ADDENDUM NO. 1
January 14, 2014

Record Storage Facility..... Old North Jail
Second Floor Renovations..... Annex

PW 14465..... Elevator at Old North Jail
PW 14498..... Elevator at Old Courthouse Annex
PW 14499..... Elevators at South Jail Parking Garage
PW 15601..... Old North Jail - A
PW 15601..... Old Courthouse Annex - B

Prepared by: Galveston County Architect
Project No.: 09-009

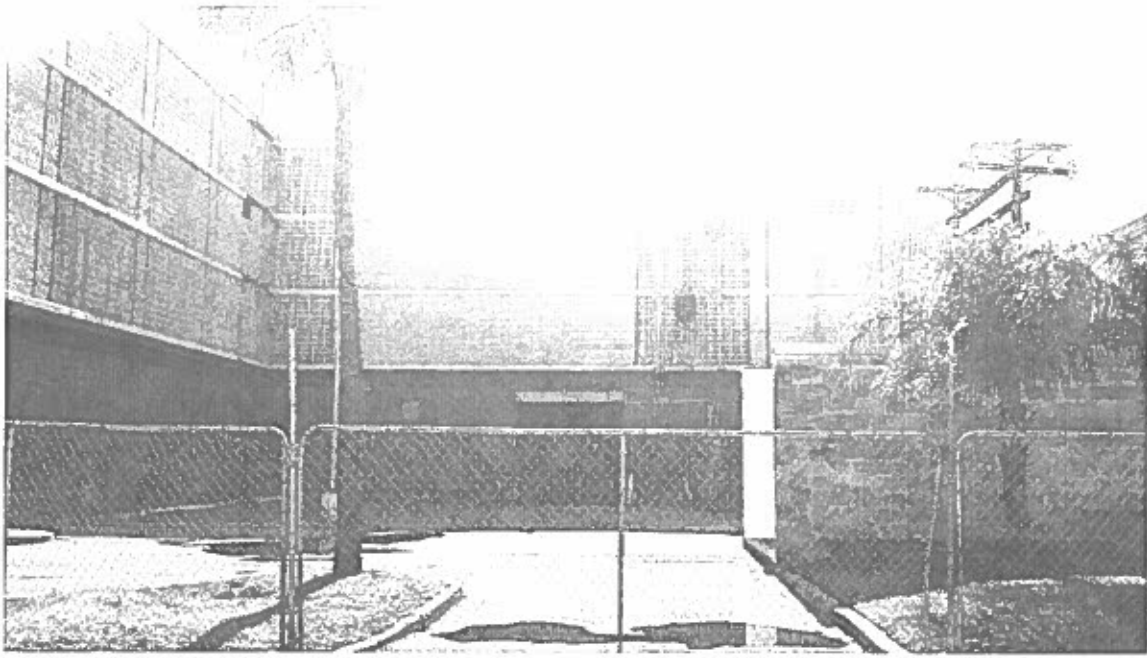
Provide masonry repair to holes in solar screen wall using Owner provided masonry units. 4 locations this photo. Provide face brick in open bay this photo. Match adjacent brick.

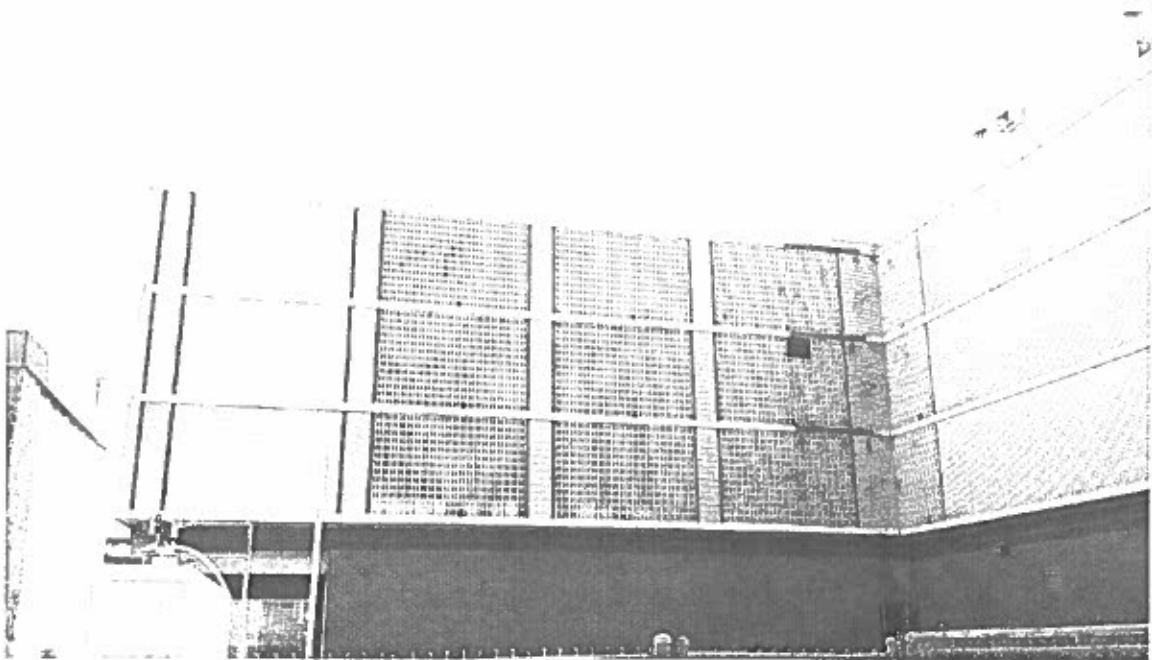
Provide masonry repair to holes in solar screen wall using Owner provided masonry units. 3 locations this photo.

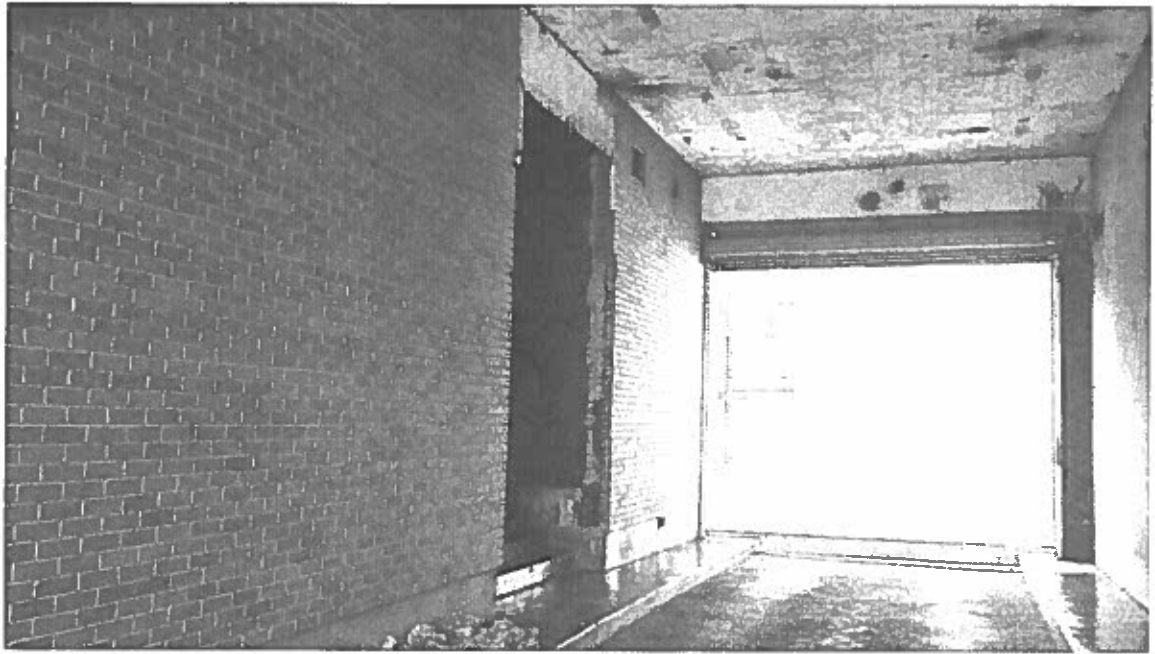
Provide masonry repair to holes in solar screen wall using Owner provided masonry units. 1 location this photo.

Provide face brick in this opening. Refer to revised sheet A1.
